CONTRACT CHANGE ORDER No. 170
SHEET ___ OF ___

ROADWAY LEVEL EASTBOUND LIGHTING AND ELECTRICAL SYSTEMS

ROADWAY LIGHTING POLE LOCATION PLAN-SHEET 46
SKYWAY STRUCTURES
NO SCALE

E-65

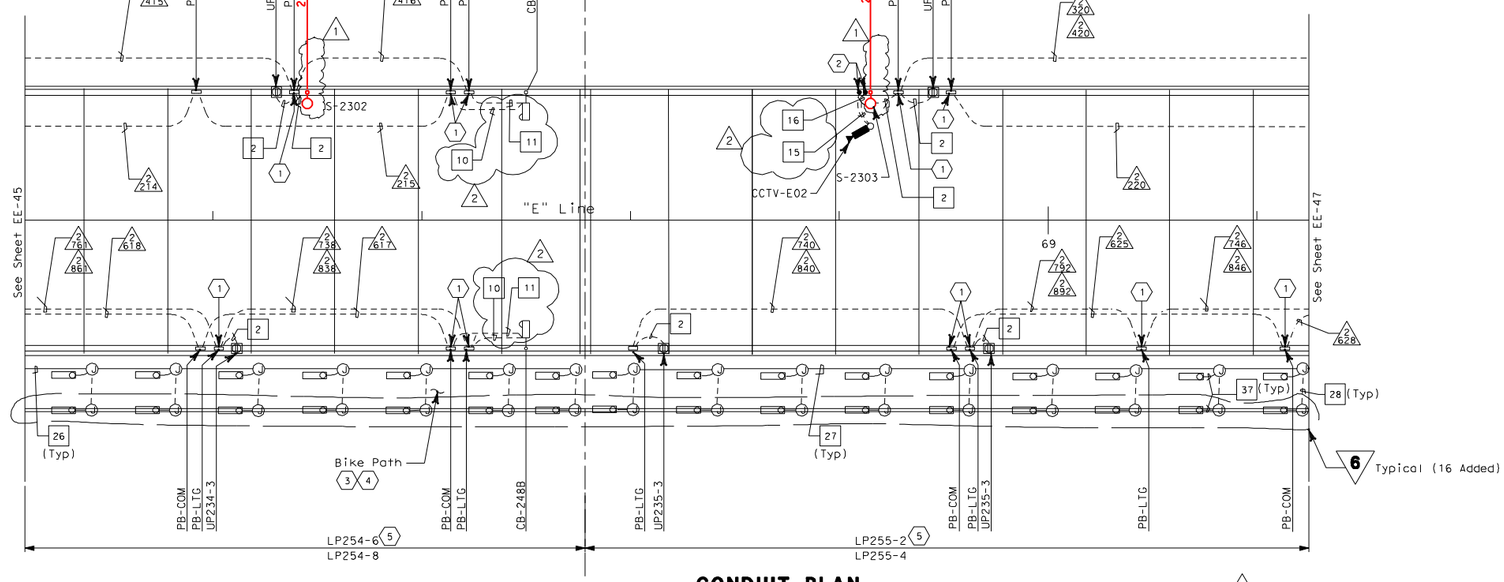
MARK	DATE	DESCRIPTIONS	REV	CK
2	1/20/06	Delete CB-248A & CB-248B. Coil 5 m of call box signal and power cable in adjacent PB-COM and PB-LTG pull boxes. Delete CCTV cable harnesses only.	JE	EJL
1	3/2/05	Delete Roadway light poles and fixtures. Coil 10m, 3#10 conductors in the pull box adjacent to light pole locations.	RS	PB
